SERVICE
513-, 514-, AND 515-TYPE KEY SERVICE UNITS
IDENTIFICATION, CONNECTION, AND MAINTENANCE
1A2 KEY TELEPHONE SYSTEM

1.001 This addendum supplements Section 518-215-405, Issue 7. Place this pink sheet ahead of Page 1 of the section.

1.002 This addendum is reissued to:

Fig. 1—515A3 Key Service Unit, Cover Removed

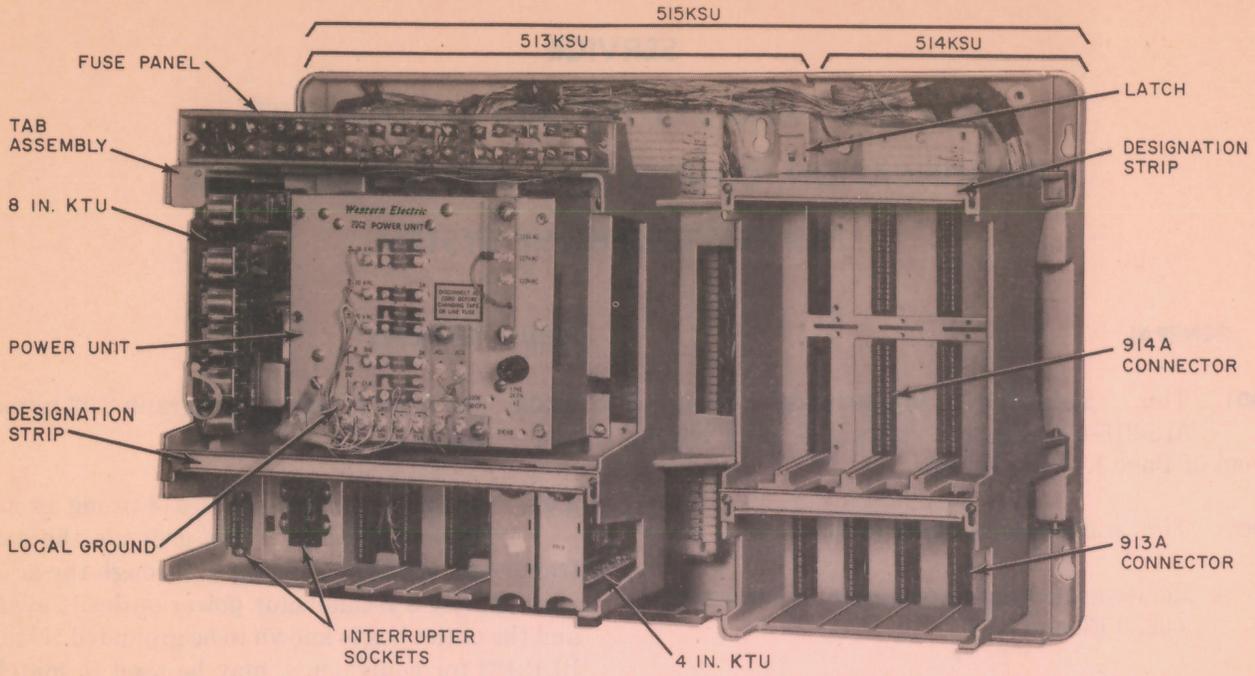
- Revise grounding information in paragraphs 3.02, 3.13, and 3.14
- Make changes on Fig. 1 to show local ground.

2.005 On Page 11, Fig. 1 is obsolete. A new Fig. 1 is shown in this addendum.
